Subject: Juniper Ridge Landfill Expansion Application, MEDEP #S-020700-WD-BI-N Follow-up to Department Staff's Responses to the March 4, 2016 Submittal on Staff's Review Comments as Presented in the Department's April 5, 2016 Letter

BGS AND NEWSME'S RESPONSE TO MEDEP'S APRIL 1, 2016 TECHNICAL MEMORANDA

I. April 1, 2016 Technical Memorandum Authored by Mr. Richard Behr

JUNIPER RIDGE LANDFILL EXPANSION LIDAR IMAGERY DEP - FIGURE 2

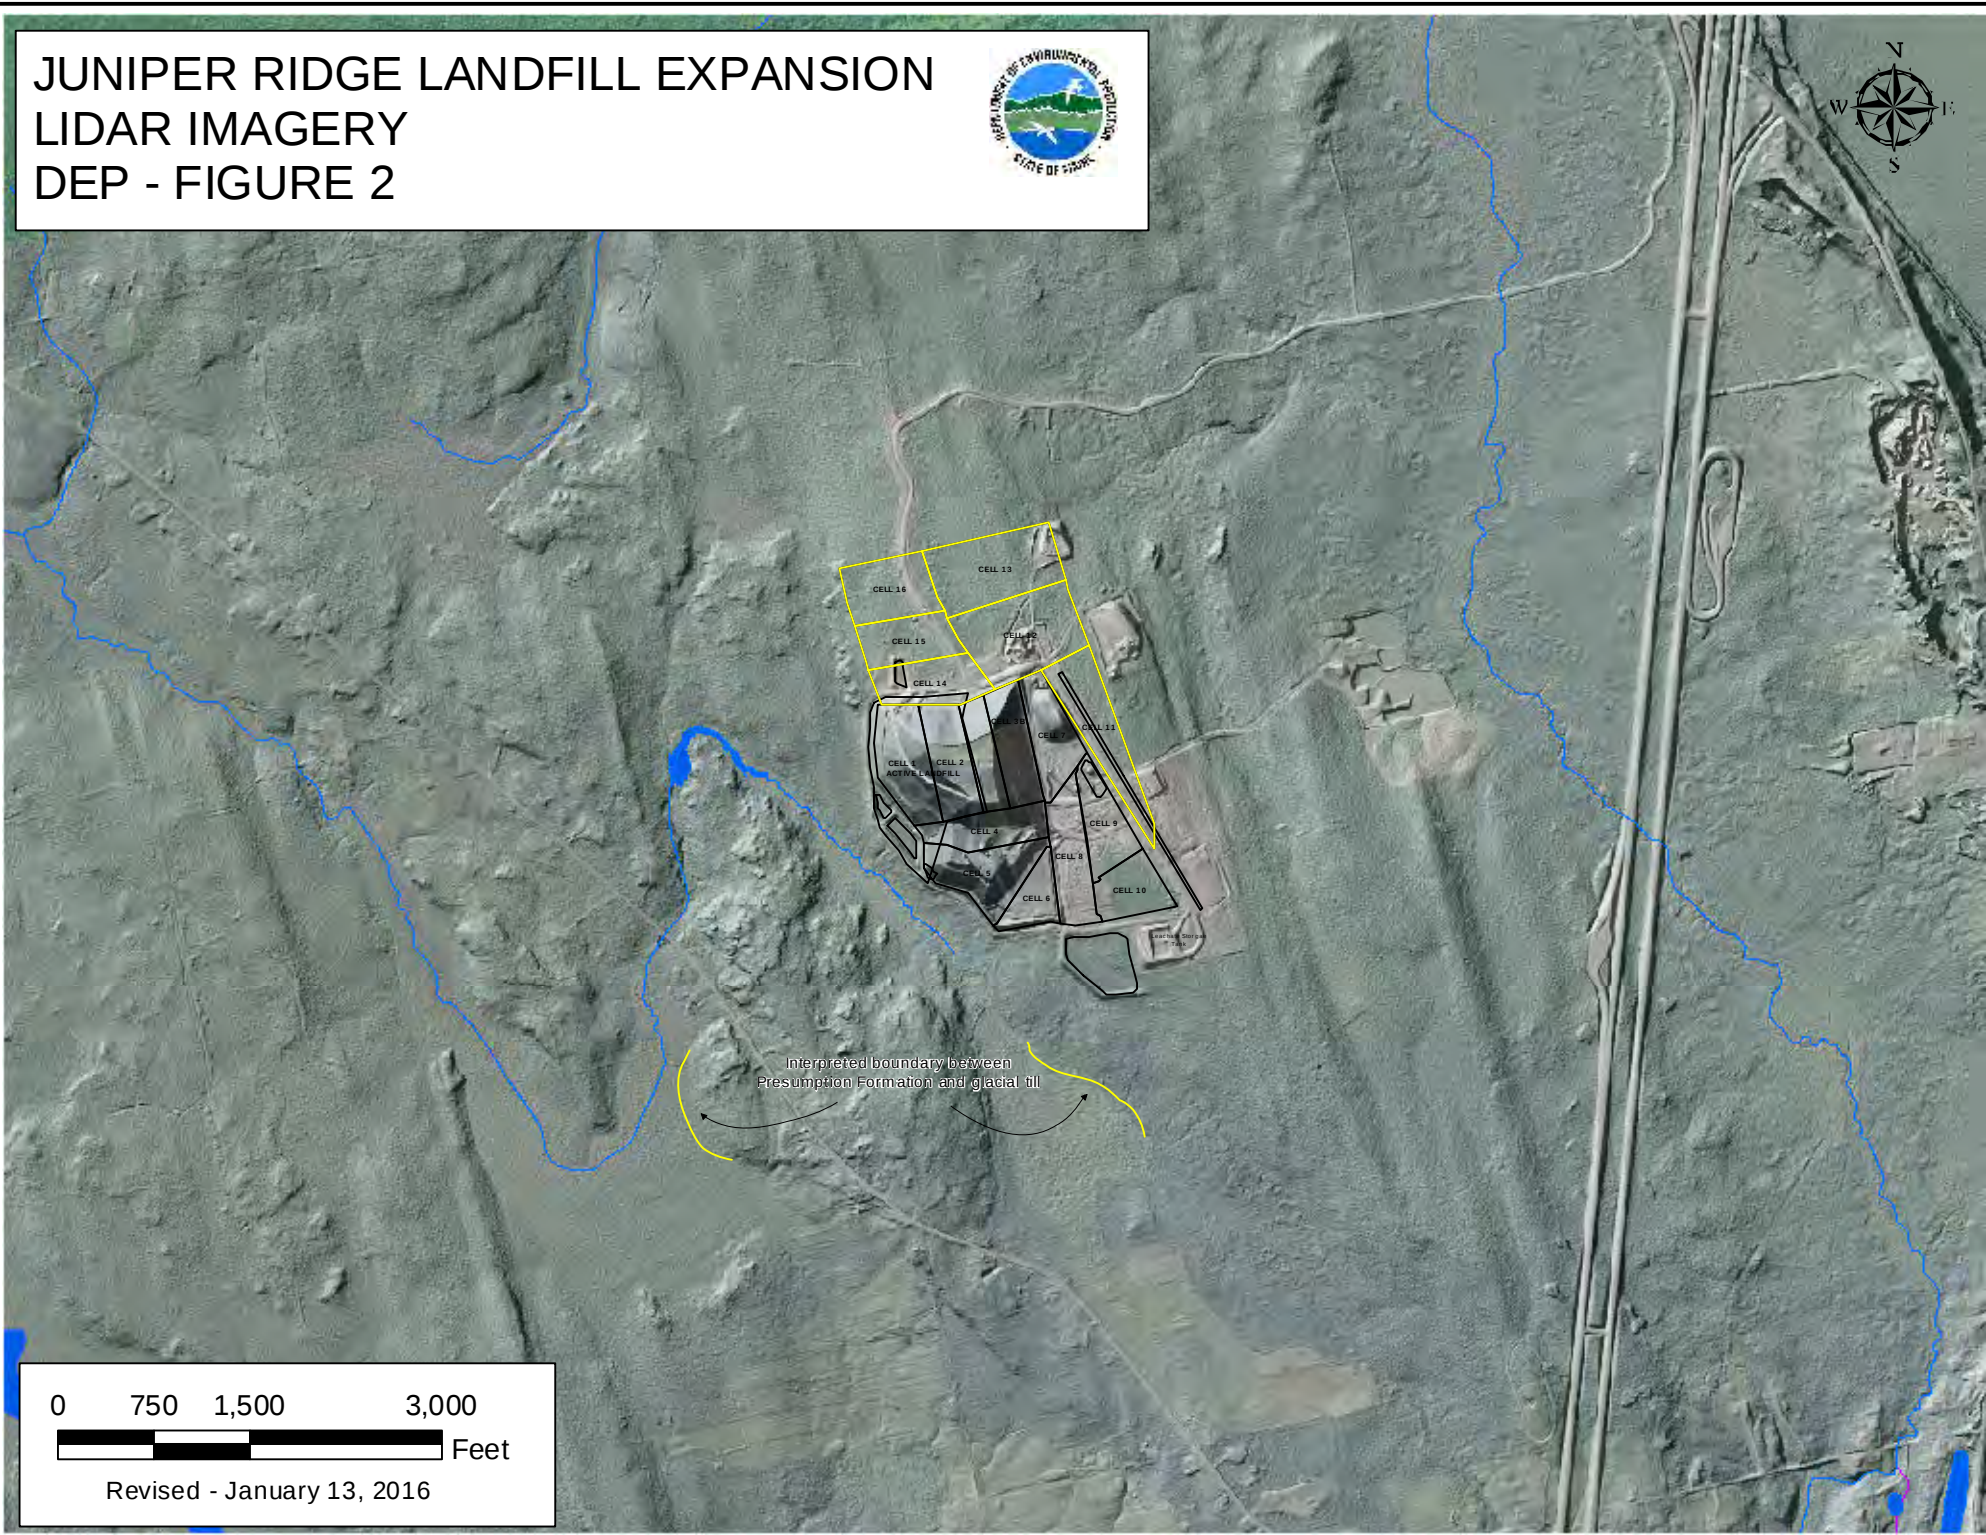
MEDEP Follow-on Response: For completeness, JRL should augment this response with a copy of the LiDAR imagery they used for their interpretations.

Applicants' Response: The LiDAR imagery used for the interpretation was attached to your January 15, 2016 memorandum. This image is included in Attachment SME-D1.

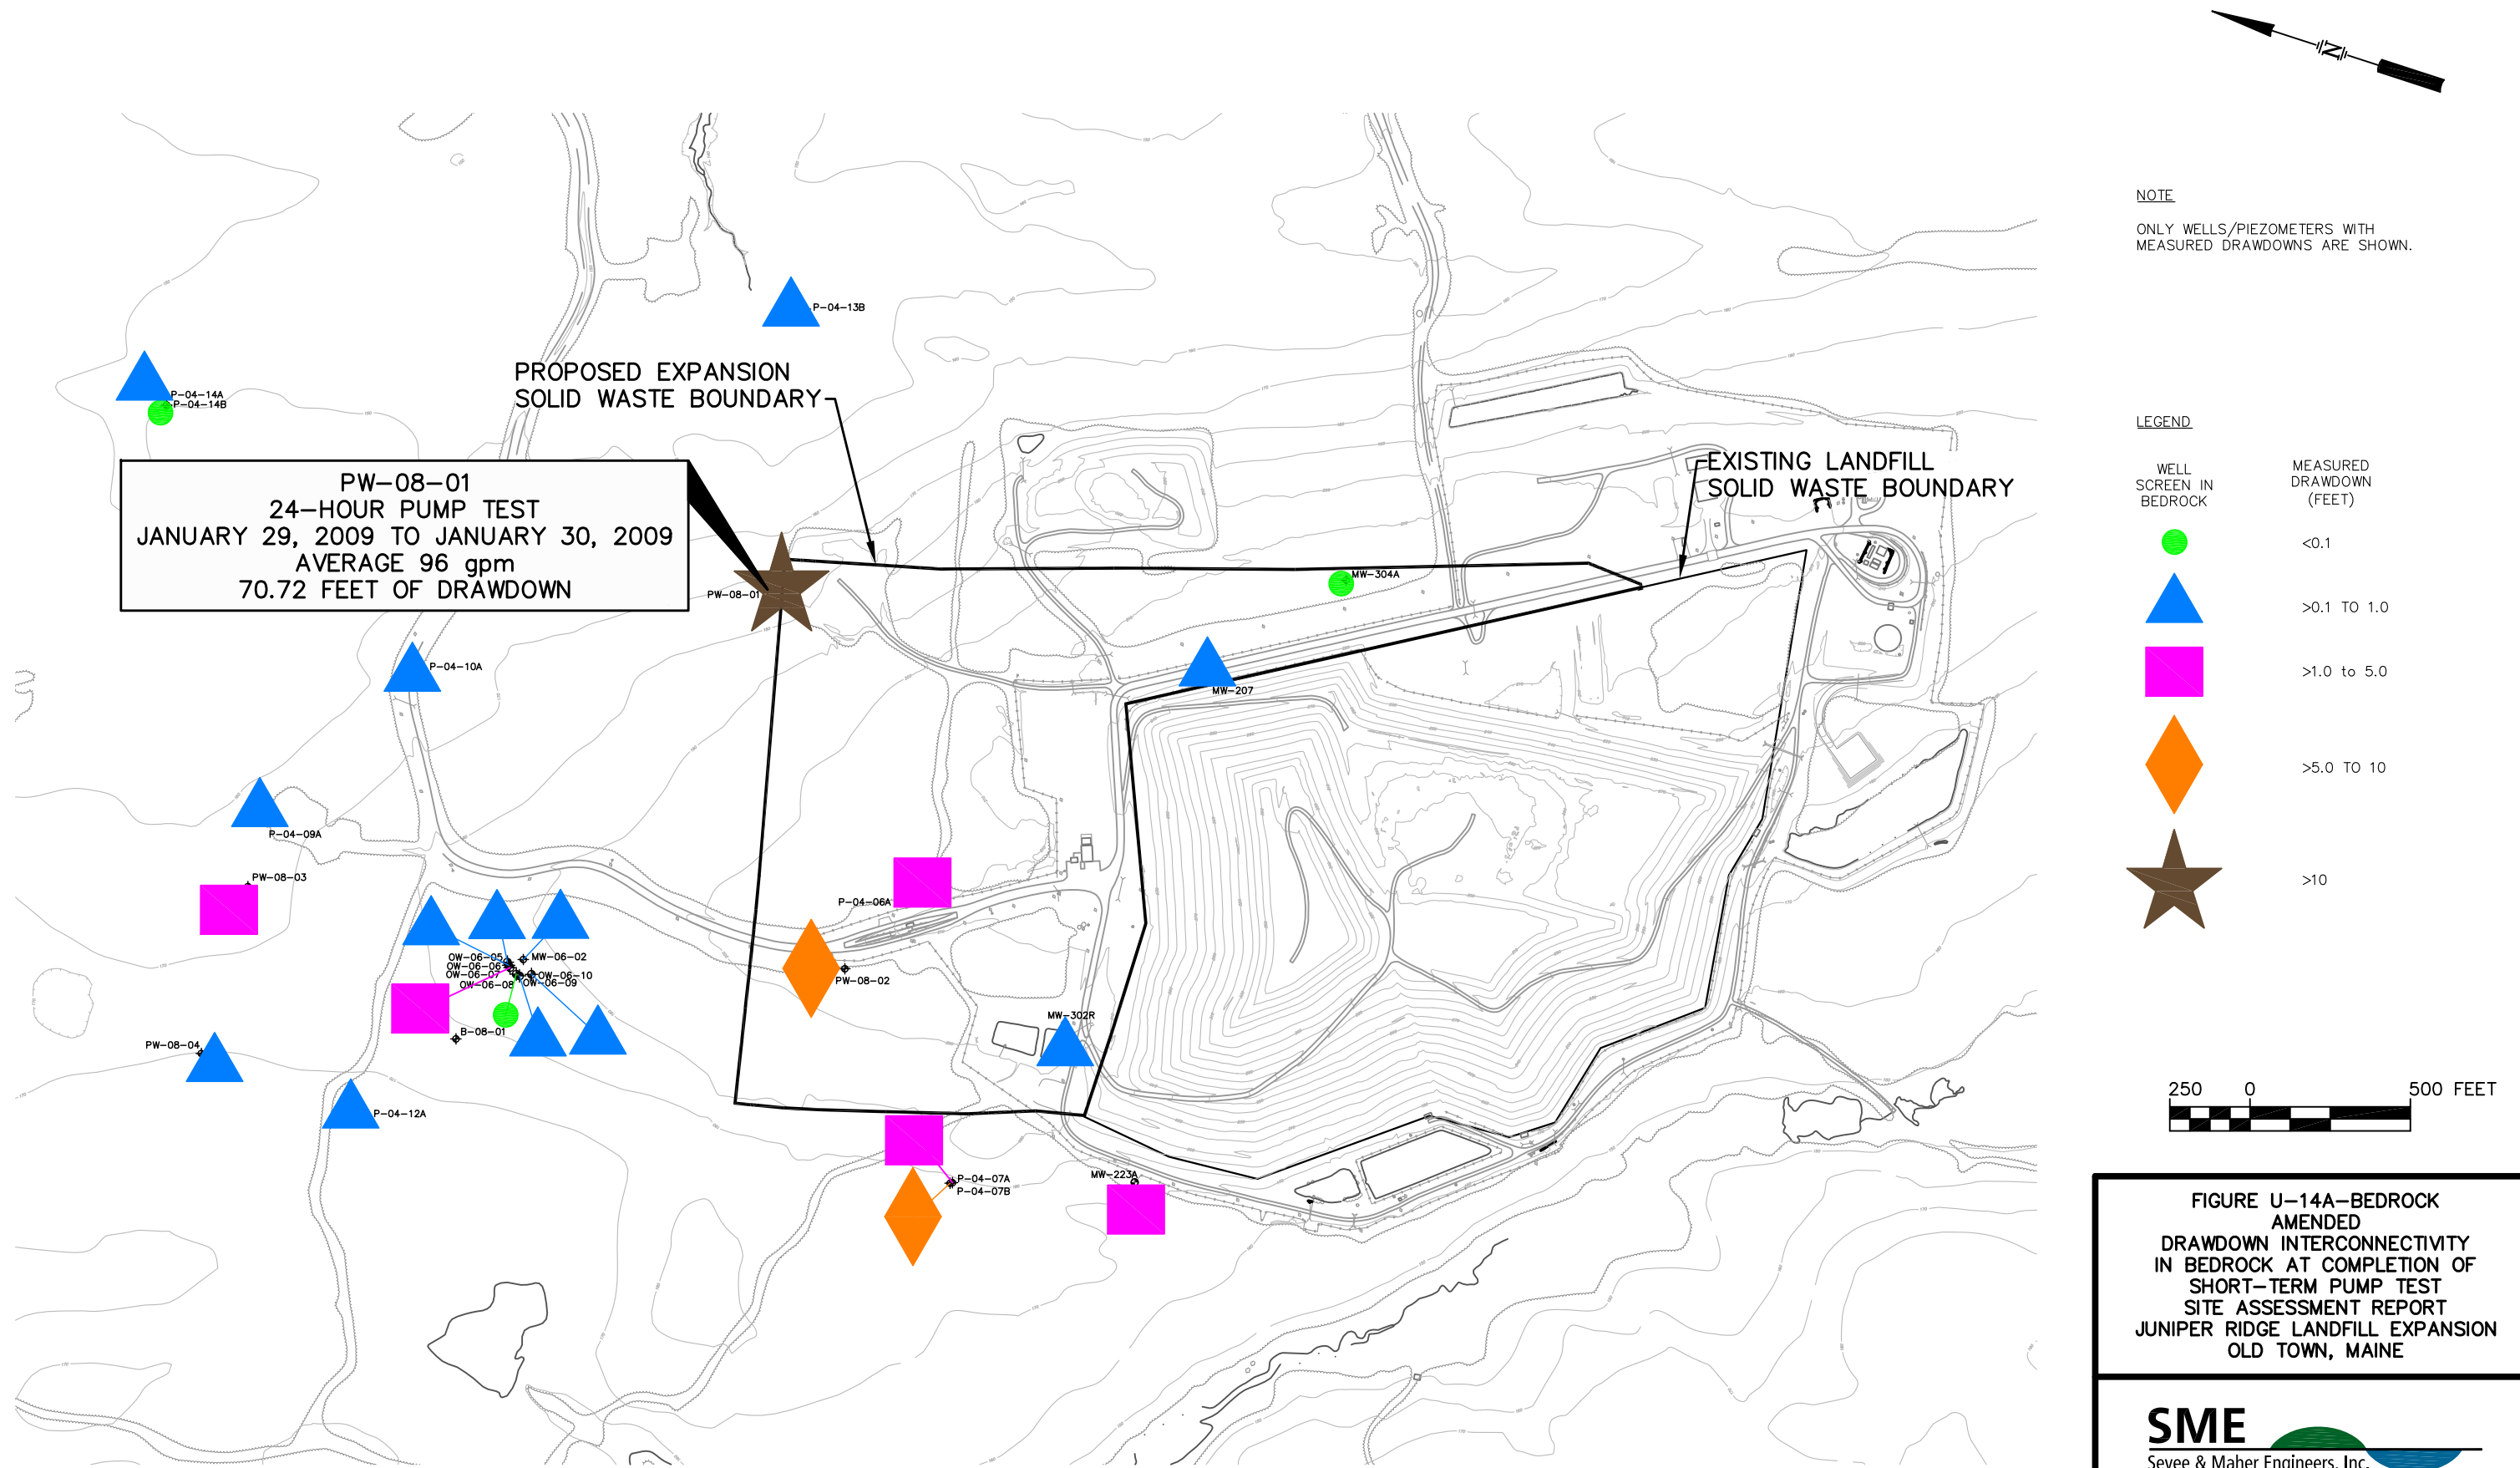
MEDEP Follow-on Response: It would also be instructive for JRL to provide a table summarizing the velocity estimates obtained from the various methods used at this site.

Applicants' Response: The table provided as Attachment SME-D2 summarizes the groundwater velocities presented in the Application, the methods used to calculate the velocities, and sections of the Application where the estimates are presented. The velocities presented in the table are based on specific conditions, and input parameters as presented in the referenced sections of the Application.
